**NYSDOT**

**RE: SEQR – Mohawk Valley Health System  
Integrated Health Campus  
Draft Environmental Impact Statement**

As requested, the New York State Department of Transportation (NYSDOT) has reviewed the Draft Environmental Impact Statement (DEIS) including the Traffic Impact Study for the proposed Mohawk Valley Health System (MVHS) Integrated Health Campus to be located in downtown Utica. Upon review of the information provided, NYSDOT offers the following comments:

STORM SEWER-OVERFLOW #108  
**THRU PRIVATE  
PROPERTY** C.T.M. 3-9-2-1  
FROM: POTTER STREET  
TO: EX. 48" BRICK  
CONTRACT DATE: APRIL, 12, 1985  
CONTRACT FINAL  
CONTRACTOR: LONGO CONST.  
ORD. #: 361  
ORD. DATE: DEC. 19, 1984

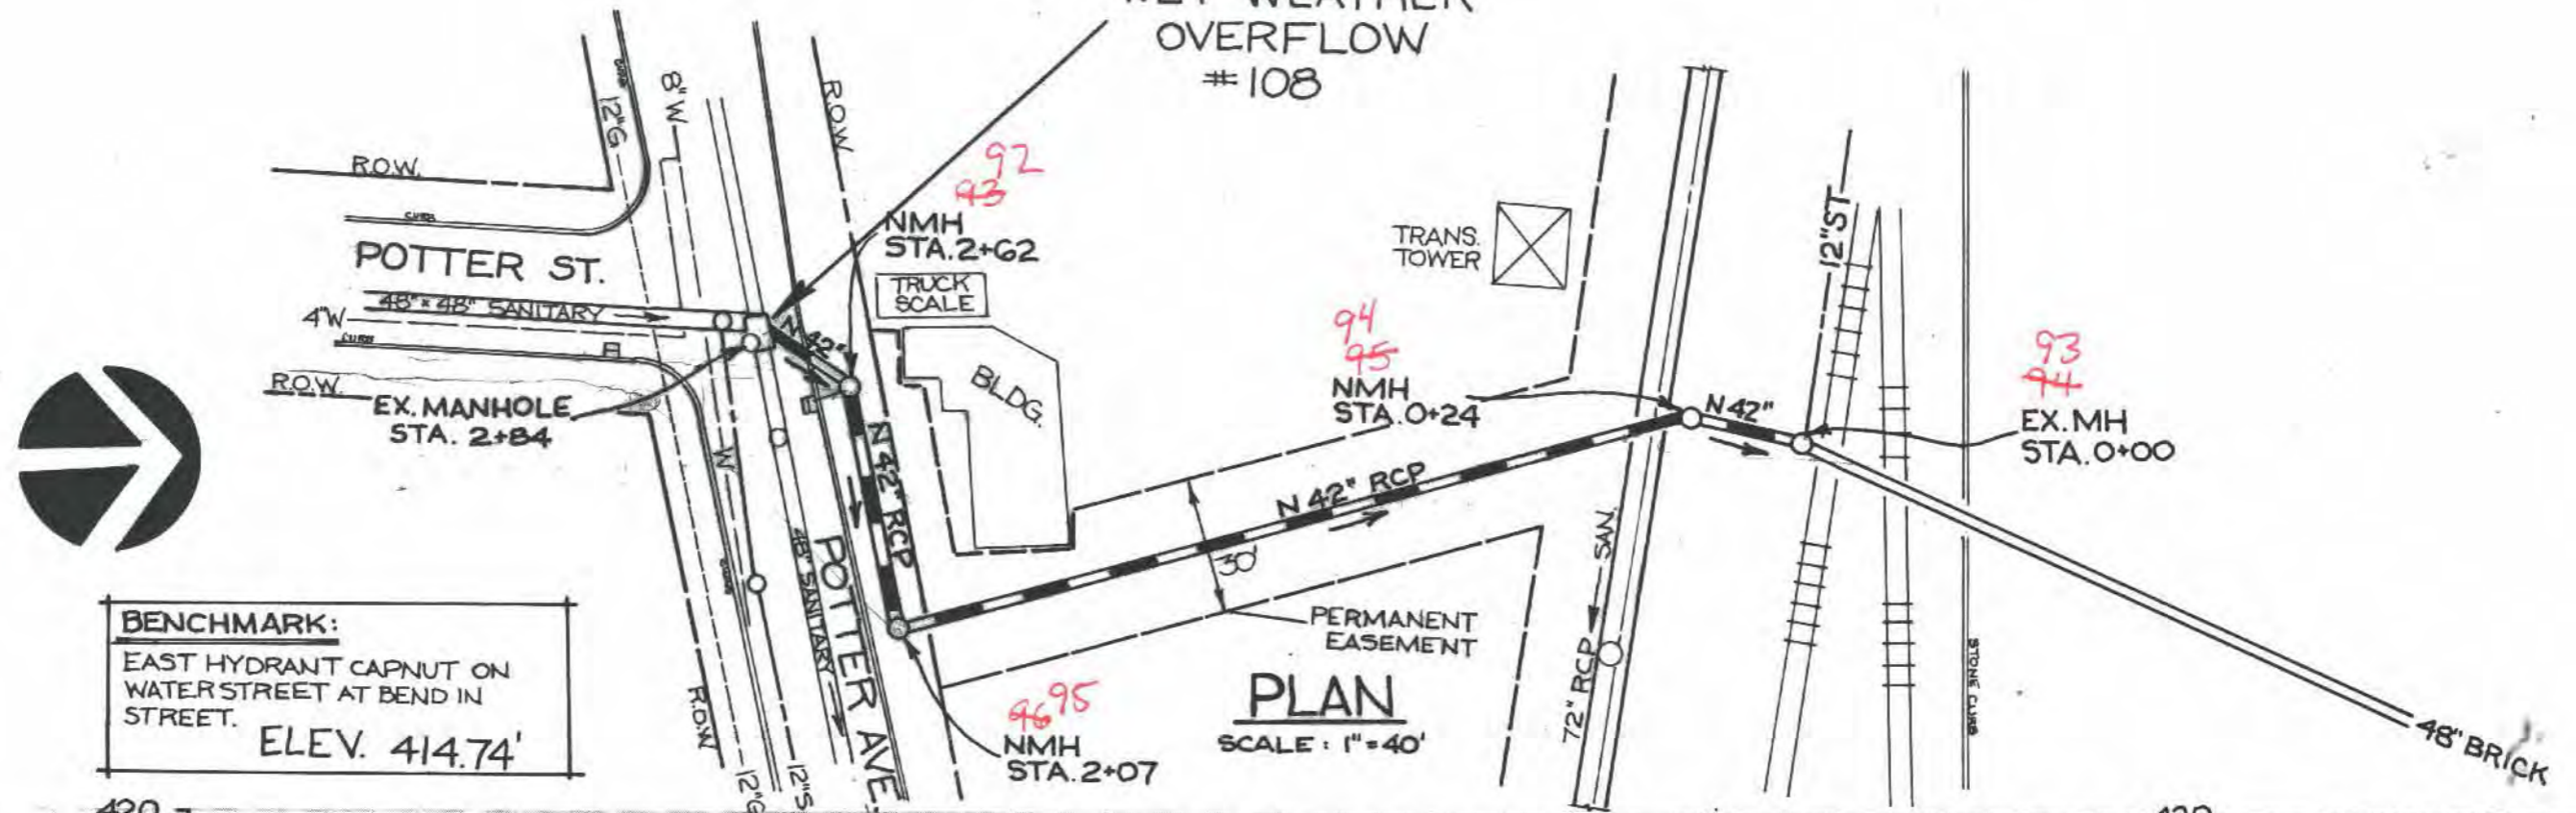
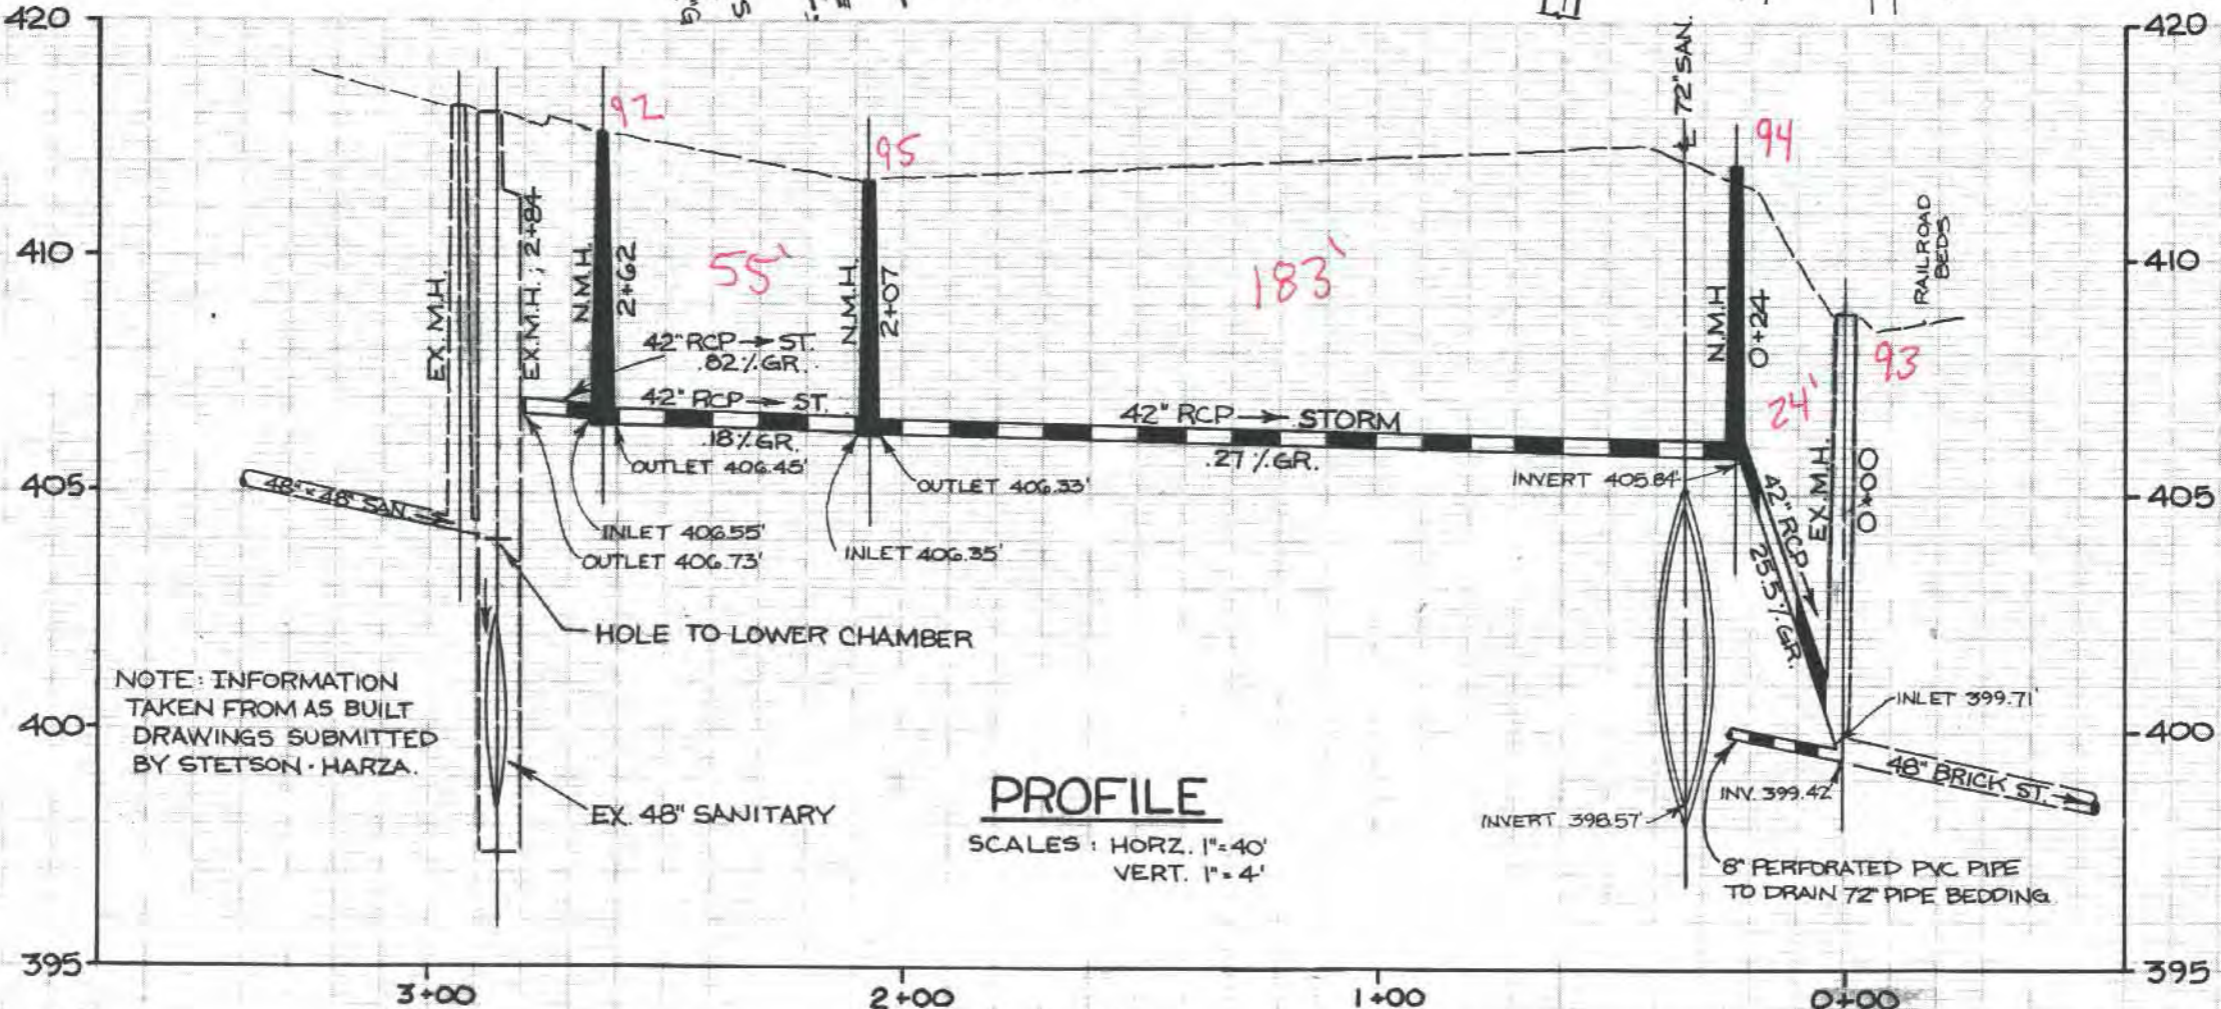
1. A Use & Occupancy permit from NYSDOT may be required for proposed parking lots adjacent to the North-South Arterial (NY 5/8/12).
2. Page 80, The existing Cornelia Street 42-inch line does not connect to the proposed outfall under CSX (A9.1) but follows Potter Street and Potter Ave under the CSX to the Mohawk via a 48-inch brick (see attached record plans provided by City of Utica). If the Cornelia Street outlet is used, a separated connection to the A9.1 proposal would be needed. Additionally, the 42-inch line that follows Auditorium Drive is not in the public right-of-way and may require acquisition for the Auditorium Authority.
3. The proposed A9.1 improvements are not shown on Figure 16.
4. Figure 17 – Existing & Proposed Water Mains. Proposed installation of a 12-inch water main along Oriskany Street East between State Street and Broadway if

1. A Use & Occupancy permit from NYSDOT may be required for proposed parking lots adjacent to the North-South Arterial (NY 5/8/12).
2. Page 80, The existing Cornelia Street 42-inch line does not connect to the proposed outfall under CSX (A9.1) but follows Potter Street and Potter Ave under the CSX to the Mohawk via a 48-inch brick (see attached record plans provided by City of Utica). If the Cornelia Street outlet is used, a separated connection to the A9.1 proposal would be needed. Additionally, the 42-inch line that follows Auditorium Drive is not in the public right-of-way and may require acquisition for the Auditorium Authority.
